2CAN030706

SUBJECT: License Amendment Request to Support a Partial Re-rack and Revised Loading Patterns in the Spent Fuel Pool
Arkansas Nuclear One, Unit 2 (ANO-2)
Docket No. 50-368
License No. NPF-6

Analysis of Proposed Technical Specification Change

Figure 3.9-1
Loading Restrictions for MPC-32

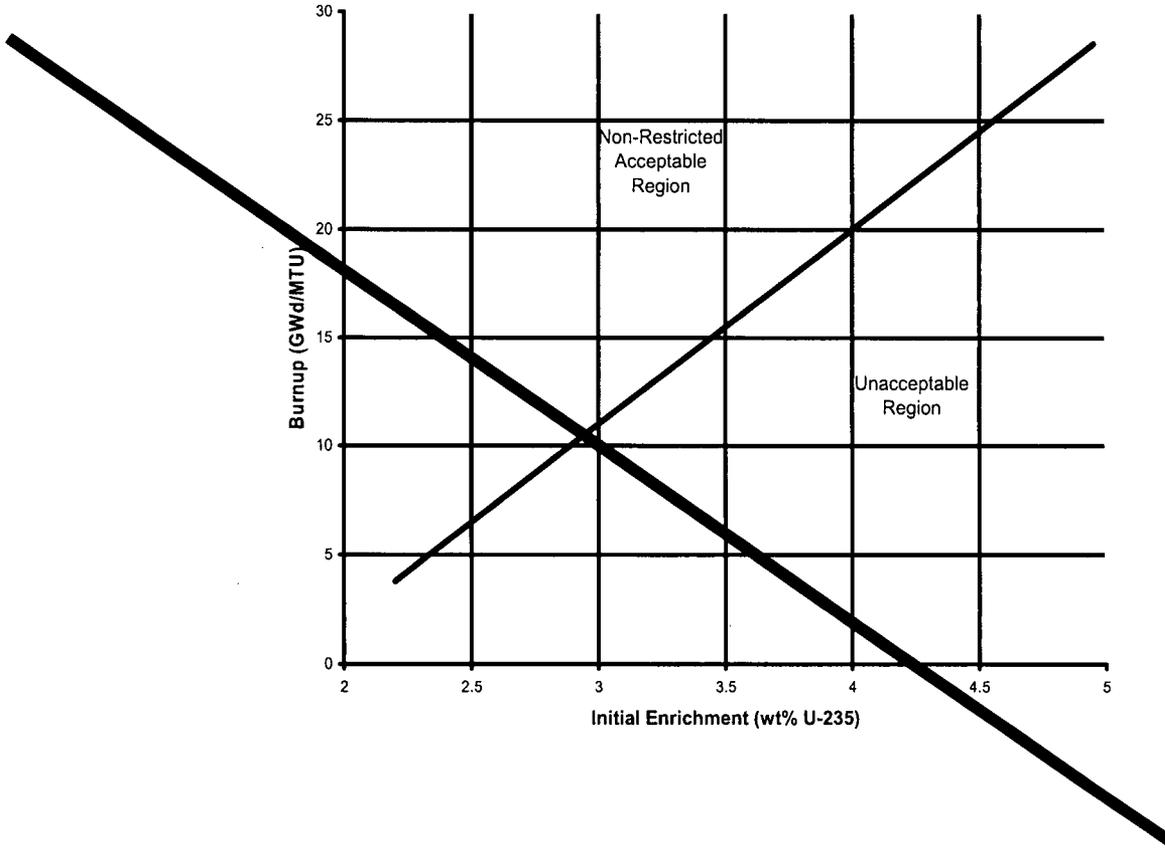
- TS 3.9.12.d, associated Figure 3.9-1, and SR 4.9.12.d will be deleted. This limiting condition for operation and loading restriction was added to support dry cask loading activities. Dry cask loading activities are not governed by 10 CFR 50.68, *Criticality accident requirements*, and therefore are not required to be included in the ANO-2 Technical Specifications that are governed by 10 CFR 50.36, *Technical specifications*.
- Surveillance Requirement 4.9.12.a will be modified to reflect the new fuel assembly U-235 enrichment.
- Surveillance Requirement 4.9.12.b will be changed to reference proposed Table 3.9-1.
- A new SR (proposed SR 4.9.12.d) will be added to direct performance of the coupon sampling program. The coupon sampling program will be added as TS 6.5.17.

Specification 3.9.12.d, associated Figure 3.9-1 and SR 4.9.12.d were added to the ANO-2 TSs to address concerns identified in Regulatory Issue Summary (RIS) 2005-05, *Regulatory Issues Regarding Criticality Analyses for Spent Fuel Pools and Independent Spent Fuel Storage Installations*. The RIS expressed an expectation that a license amendment request be submitted to add a TS to the site's Part 50 license restricting the minimum burnup of fuel assemblies loaded in dry casks in accordance with the criticality analysis guidance contained in 10 CFR 50.68. On January 30, 2007, a new revision to 10 CFR 50.68 became effective. The revision added paragraph (c) which states that the requirements in 10 CFR 50.68(b) do not apply to the fuel located within a dry cask when the dry cask is in the spent fuel pool. Therefore, TS 3.9.12d, SR 4.9.12d, and associated Figure 3.9-1 will be deleted.

Figure 3.9-2

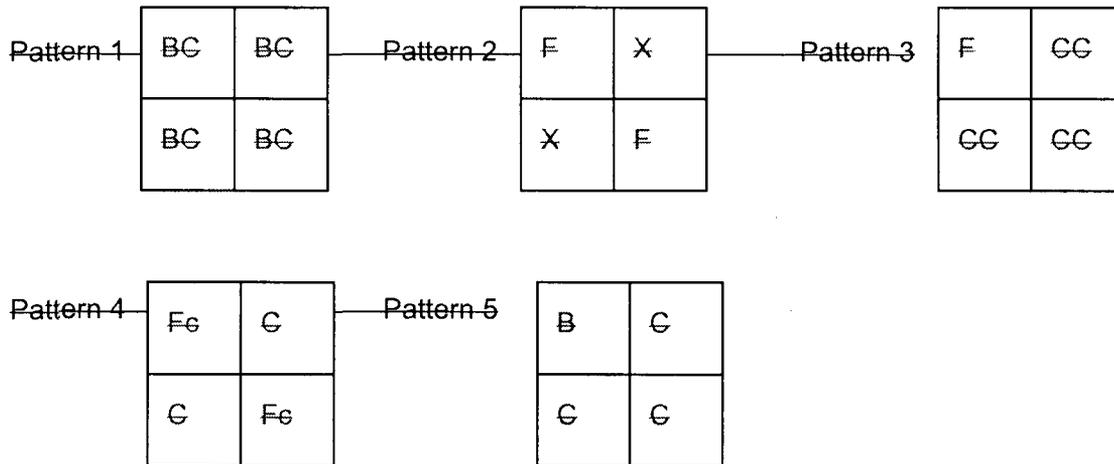
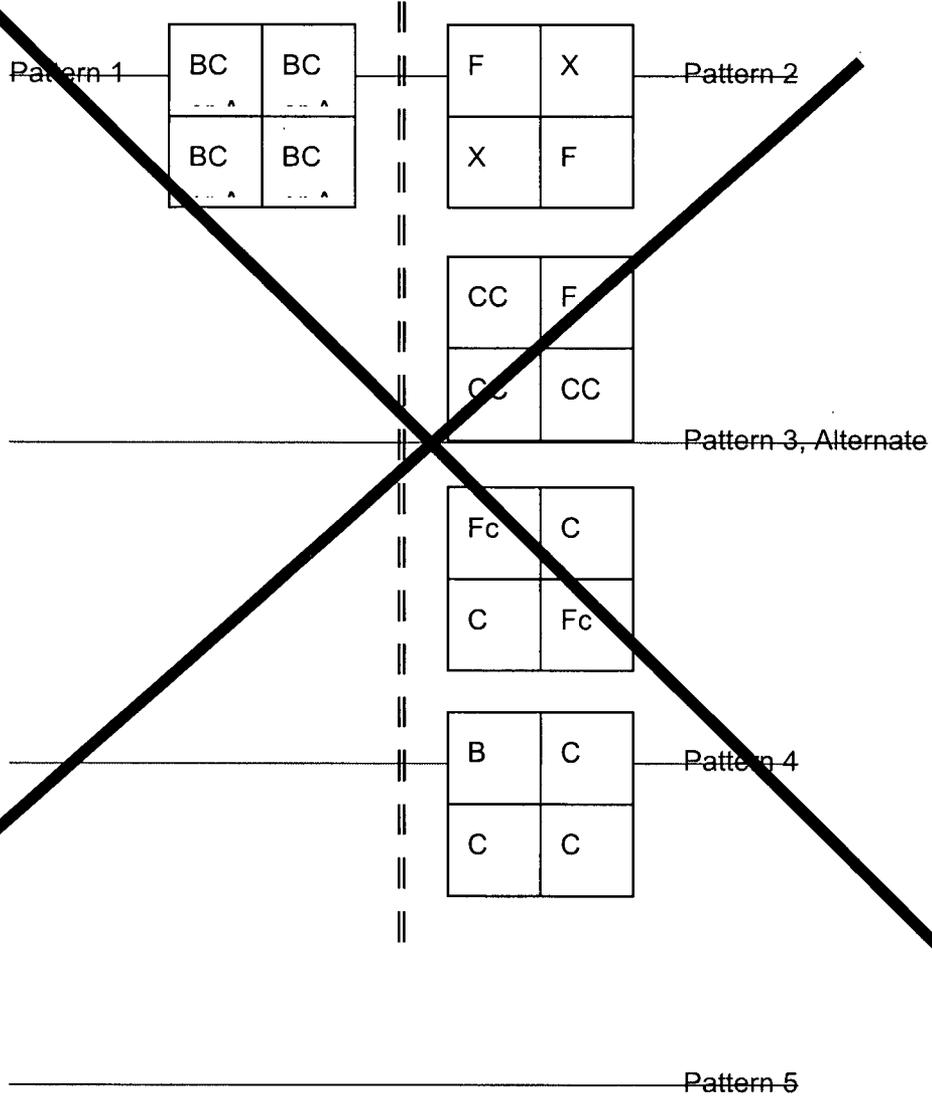
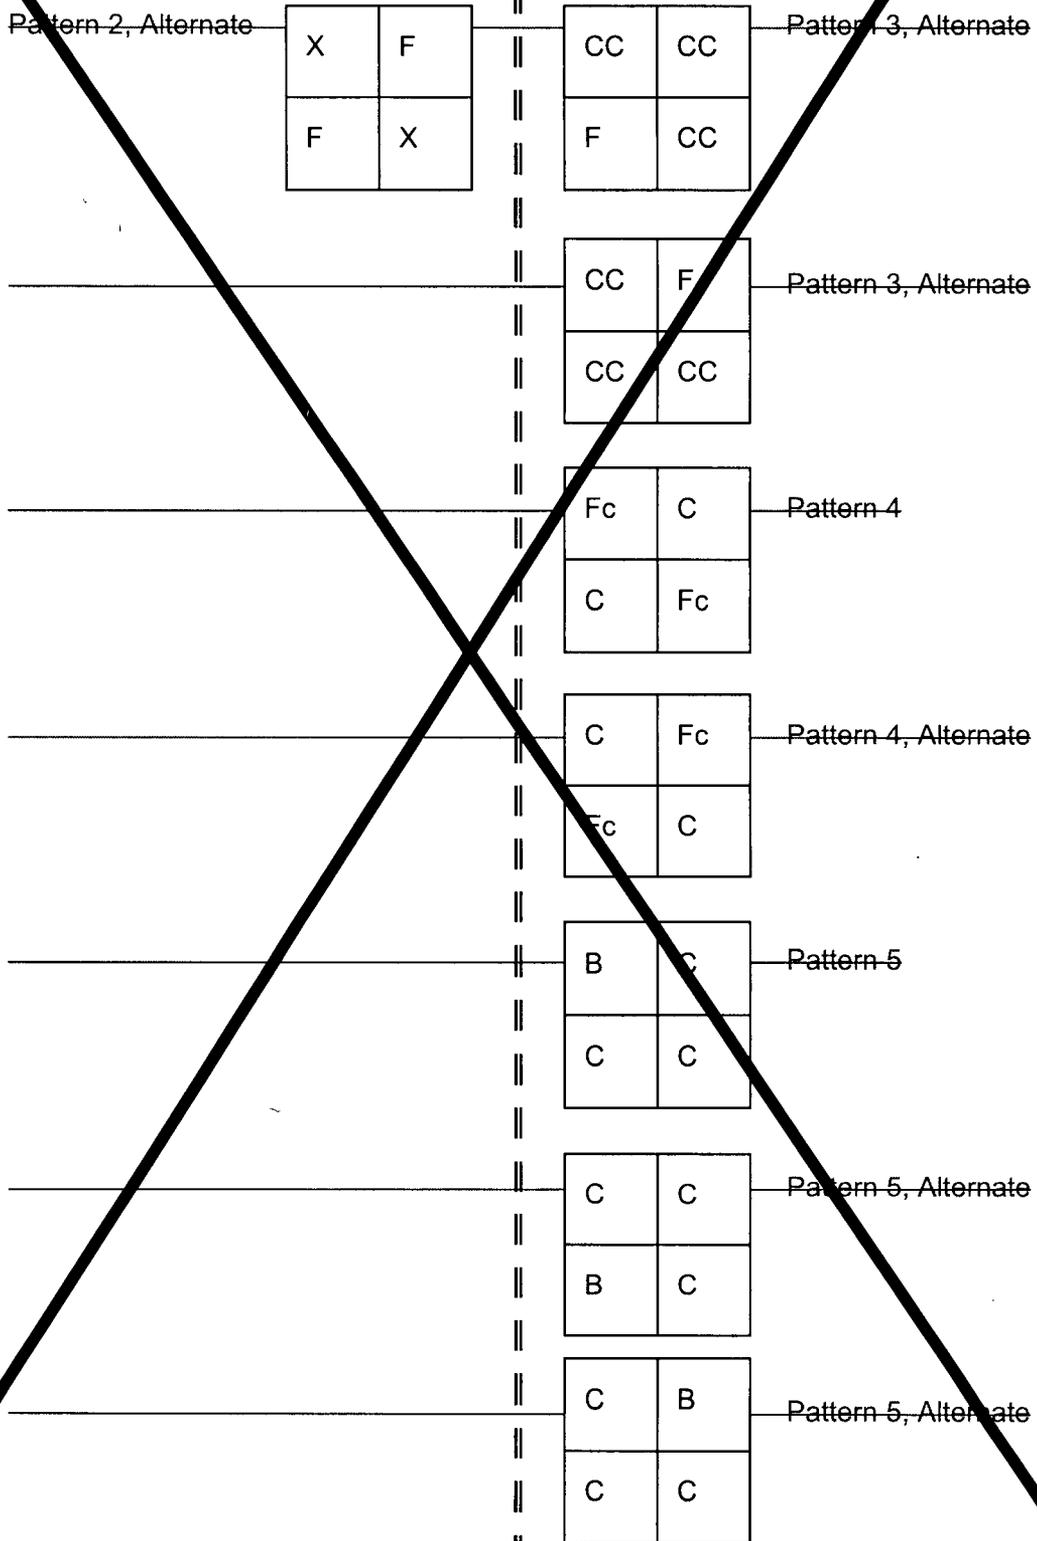
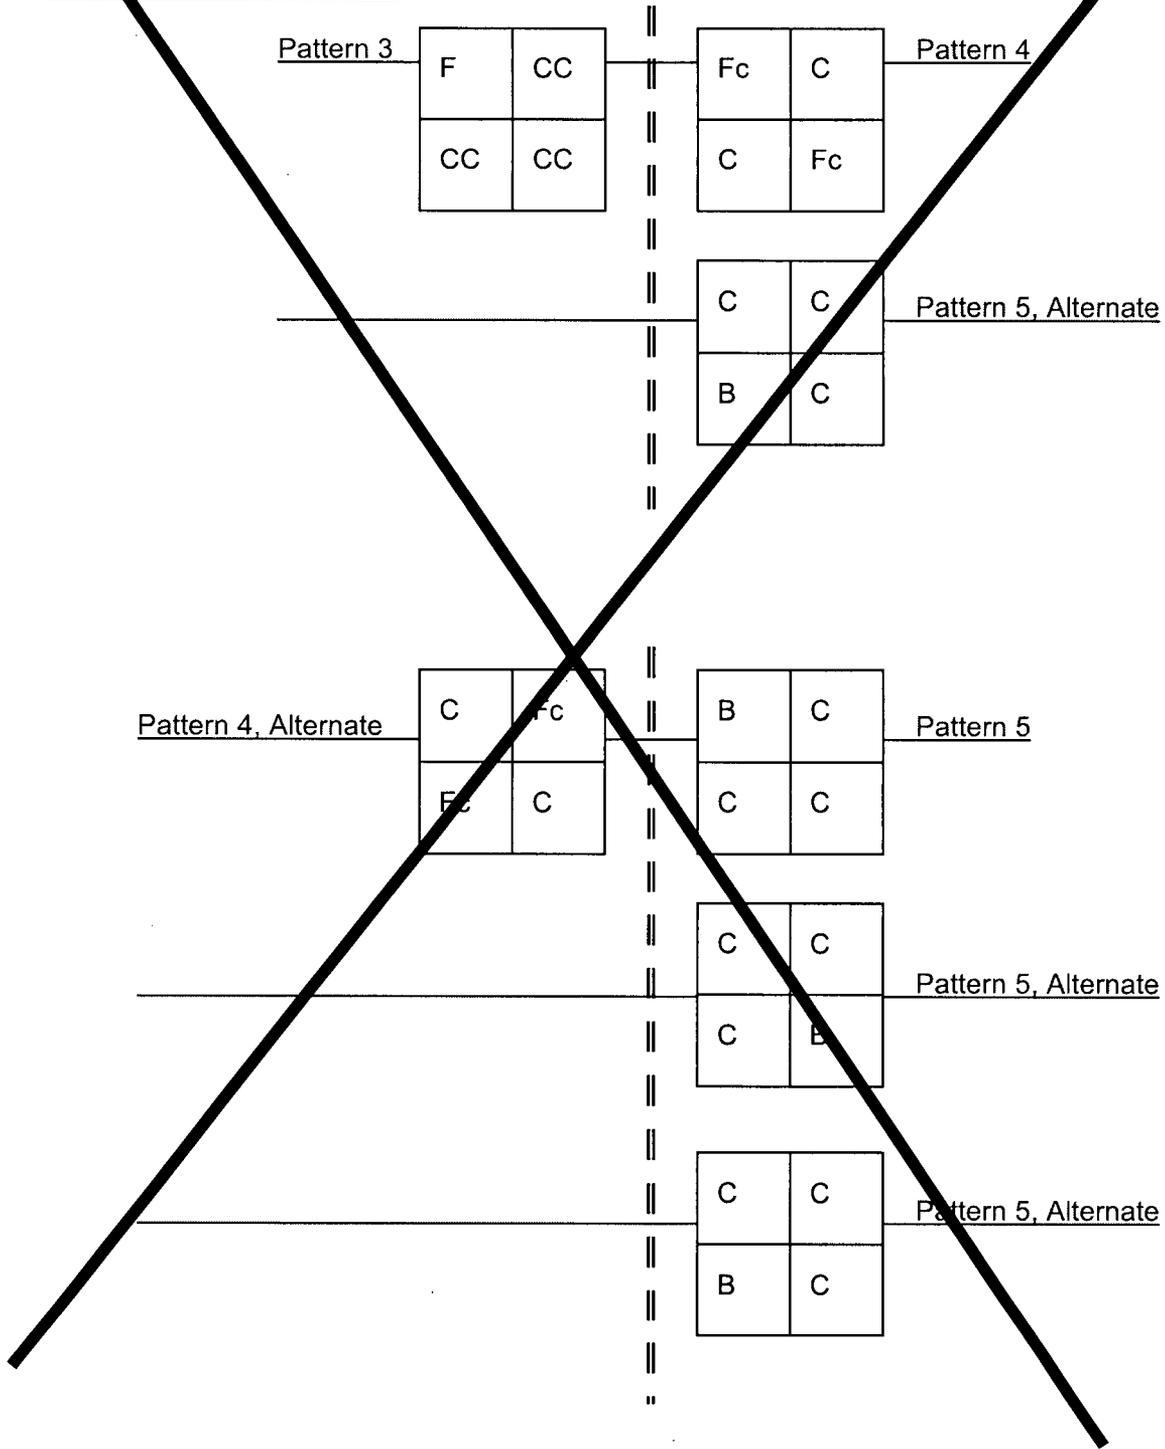
- TS 3.9.12.a, which defines the fuel assembly U-235 enrichment, will be changed to allow storage of fuel assemblies with an initial U-235 enrichment of 4.95 wt%.
- TS 3.9.12.b and Figure 3.9-2 define loading restrictions for fuel assemblies that are stored in the ANO-2 SFP. Figure 3.9-2 will be deleted and revised loading restrictions, which will be reflected in proposed Table 3.9-1, will be added.

Racks must be loaded using one of the five patterns shown in Figure 3.9-2. The type "A" and "C" assemblies have restrictions which are designated in Tables 1, 1-1, 2, and 2-1 of Figure 3.9-2. In any pattern, a less restrictive assembly may be substituted for another assembly within the pattern.

For adjacent patterns, both inside and between racks in the SFP, only the allowed interface configurations shown in Figure 3.9-2 may be used.
